DEPARTMENT OF ENVIRONMENTAL QUALITY DIVISION OF WATER QUALITY

RE: Proposed Topaz Beryllium Venture
Facility Plan Comments

LEACH PAD DESIGN

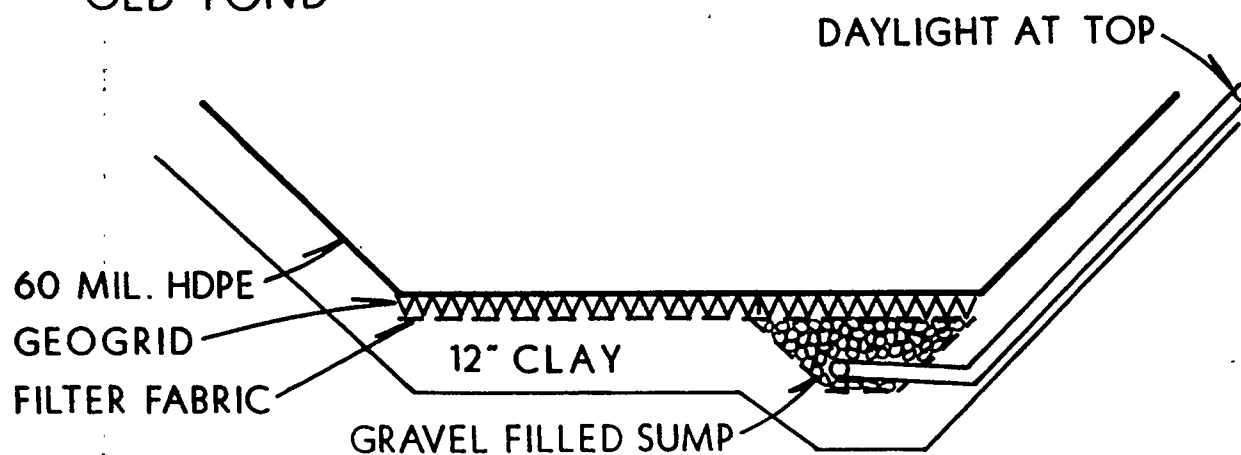
The revised configurations, for the pads and ponds, proposed in the meeting, (copies attached) are adequate to proceed to a preliminary design. For the leach pad, you should evaluate the stability of the base and sub-base material to support the pavement structure, which will have heavy equipment and ore loads. Adjustment of depths, and materials may be required. The leak detection media should have a hydraulic conductivity of 1×10^{-1} cm/second or more. The capillary rise value for the media should be less than 12 inches. The gravel in the pond sump should be enveloped by a geotextile for protecting the HDPE liners.
